# DOCUMENT CHANGE REQUEST

| DCR number 296 | Changes required for: General | Originator: Philippe Baviere |

| Title: | Switches Thermostatic Bimetallic SPDT Opening Contact | | |
| Number: | 3702/001 | Issue: | 3 |

FIGURE 2(a) - VARIANT 01 (Note 3)

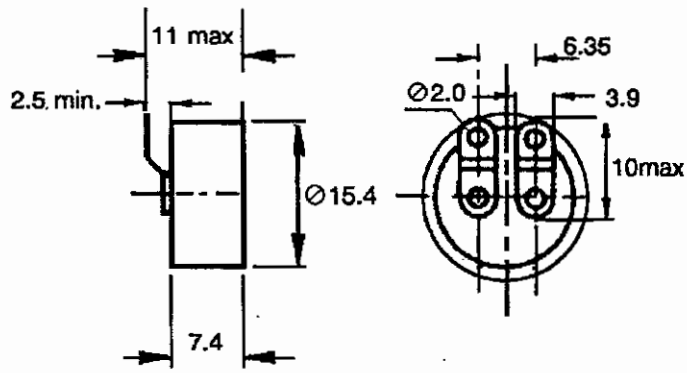
Add new note 3 to titles of Figures 2(a), 2(b) 2(c)
Note 3. Dimensions applicable to the body and terminals of variant 01 shall also apply to variants 02 and 03.

FIGURE 2(b) - VARIANT 02 (Note 3)

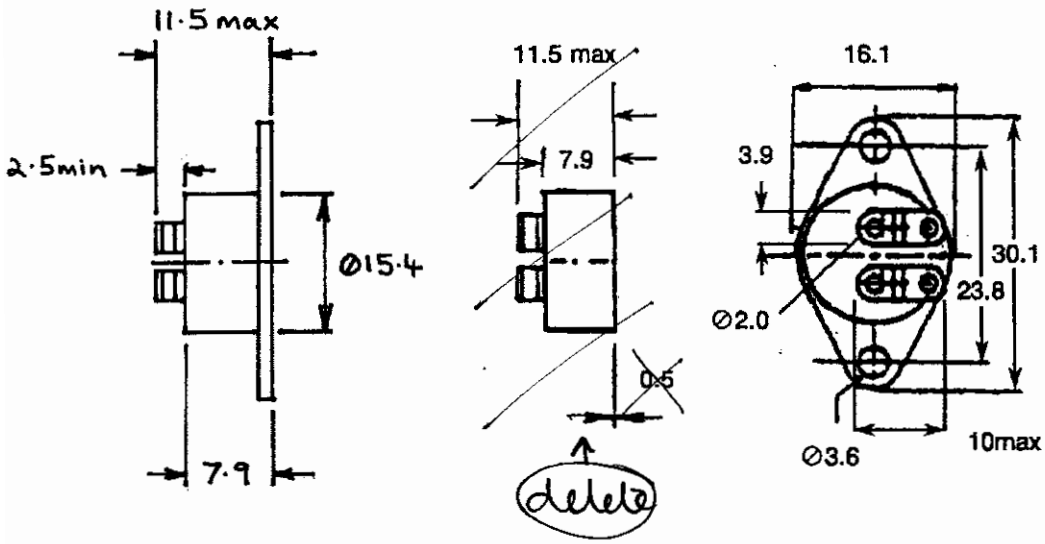
See attached modified new drawings for Figures 2(b) and 2(c) including:
for Figure 2(b) - delete flange thickness (0.5); add terminal height (2.5min) and body diameter (15.4)
for Figure 2(c) - delete stud base thickness (1.5); add terminal height (2.5min) and total body thickness (8.2)

Justification
Drawing for variant 02 was wrong (flange was missing).
Total body thickness was missing for variant 03.
Clarification that the body and terminal dimensions are the same for variants 01, 02 and 03.

FIGURE 2(d) - VARIANT 04

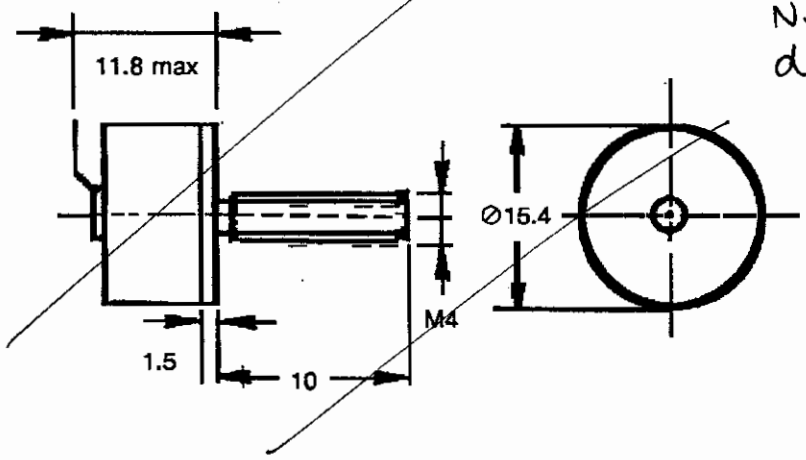
Note: delete fig 2(d) per DCR282
